CEDAR BOULEVARD RESIDENTIAL DEVELOPMENT

Response to Comments on the Draft Initial Study &
Mitigated Negative Declaration
(SCH # 2022120529)

May 2023

FIGURE 2

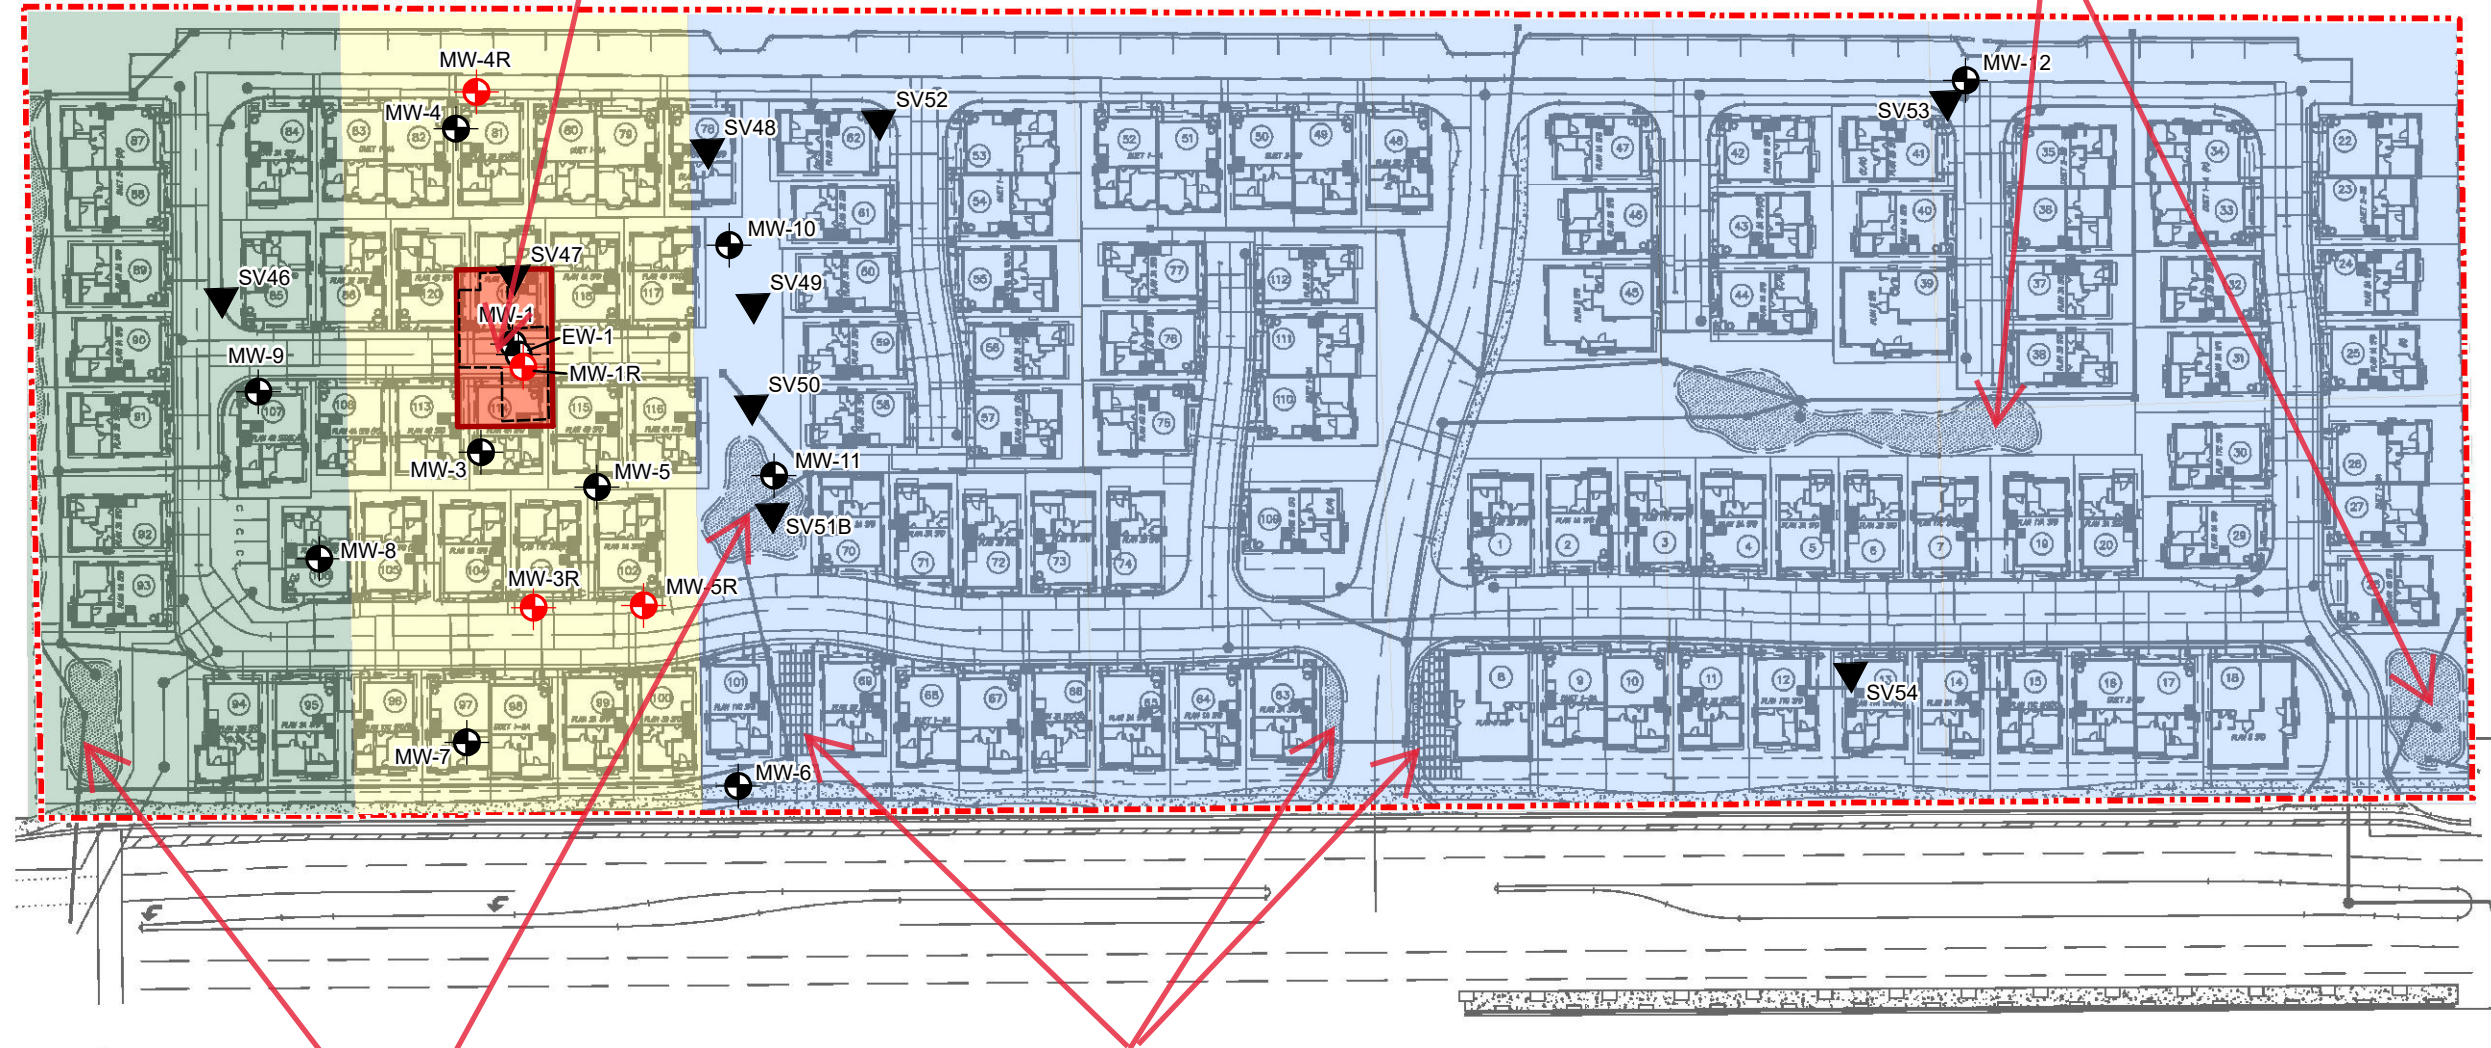
<p>c. Stormwater Management:</p> <p>Pages 10, 11, 74, and 115 of the draft IS/MND state that four of the proposed open space areas on site would include bioretention areas for stormwater. ACWD appreciates the biotreatment of stormwater in bioretention areas to impede runoff from rapidly infiltrating the subsurface and bypass soils which have the capacity to remove pollutants and protect the groundwater supply. In order to protect the groundwater basin, ACWD provides the following comments regarding onsite stormwater management:</p>	
<p>i. To protect the groundwater supply, the proposed stormwater system and treatment measures should be carefully evaluated. Because the Project is located near one of ACWD’s water supply wells (i.e., Bellflower), as well as in a wellhead protection area within the groundwater basin, the types of pollutants, loading, and the proposed treatment measures could present an unacceptable long-term risk to beneficial uses of groundwater. Therefore, the land use is critical in determining what kind of stormwater system and treatment measure requirements are appropriate.</p>	<p>As indicated on page 73 of the IS/MND, the project would be subject to the National Pollutant Discharge Elimination System (NPDES) C.3 requirements of the Municipal Regional Stormwater Permit (MRP). Provision C.3 requires source control, site design, and stormwater treatment measures to address stormwater pollutants. A condition of approval ‘nn’ for the project, requires that the Stormwater Treatment Plan complies with the Municipal Regional Stormwater NPDES Permit (MRP). Alameda County C.3 Stormwater Technical Guidance, which is a handbook supporting the MRP, discusses the use of an impermeable liner and placement of an</p>

<p>underdrain on top of the liner to prevent infiltration if there is less than 5-ft separation between the bottom of the stormwater facility and the seasonal high groundwater elevation. This is an acceptable county-wide practice in eliminating potential pollutants from entering the groundwater that would be applicable to the project.</p> <p>Additionally, condition of approval “ddd” for the project requires that all improvement plans are reviewed and approved by the Alameda County Water District (ACWD) along with other applicable regulatory agencies where the applicant is solely responsible for any modifications to the site design provided with the vesting tentative map as necessary to satisfy requirements from the agencies. No revisions to the IS/MND are necessary in response to this comment.</p>
<p>ii. Page 74 of the draft IS/MND states, “The proposed project would include 10,887 square feet of landscape area including bioretention that would result in some groundwater recharge. Therefore, the proposed project would not impact groundwater supplies or recharge adversely and, thus, would not impede sustainable groundwater management of the Niles Cones basin.” Please note that loss of groundwater supply is not the only sustainability indicator for sustainable groundwater management; water quality degradation is also a sustainability indicator. Since there is known and potential soil and groundwater contamination present within the Project boundaries, the proposed locations of the bioretention should be fully evaluated in terms of preventing any groundwater quality degradation, adverse impacts to groundwater supplies, and movement of the onsite groundwater contaminant plume. Therefore, ACWD requests the draft IS/MND evaluate the proposed locations of the bioretention in relation to known soil or groundwater impacts and include a requirement that Project proponents coordinate the design and installation of the bioretention with ACWD.</p>	<p>The Phase I Environmental Site Assessment (ESA) prepared for the project and included as an appendix (Appendix 5) to the IS/MND discusses the soil and groundwater conditions on the project site and indicates that groundwater contamination on the project site is primarily limited to the former underground storage tank (UST) area in a portion of 38370 Cedar Boulevard that is part of the project site. On page 2, the assessment states, “No migration of this impact has occurred since groundwater monitoring activities began in 1989.” The proposed location of the bioretention areas on the project site is away from the area of groundwater contamination, shown in red in the attached exhibit (Exhibit A). The location of the area of groundwater contamination is not anticipated to have significant impact on groundwater quality because contamination on the site is localized and away from the proposed bioretention areas. Further, the improvement plans for the project would include the proposed bioretention areas and are required to be reviewed and approved by the ACWD per condition of approval “ddd”. Therefore, no revisions to the IS/MND are necessary in response to this comment.</p> <p>Subsequent to the submittal of the Comment Letter, the City conducted a meeting with ACWD representatives on April 27, 2023, to discuss the ACWD’s concerns regarding the proposed bioretention areas expressed in the letter and the City’s proposed approach to addressing those concerns. This response and the response to Comment c.i in the Comment Letter reflect the discussion during this meeting.</p>
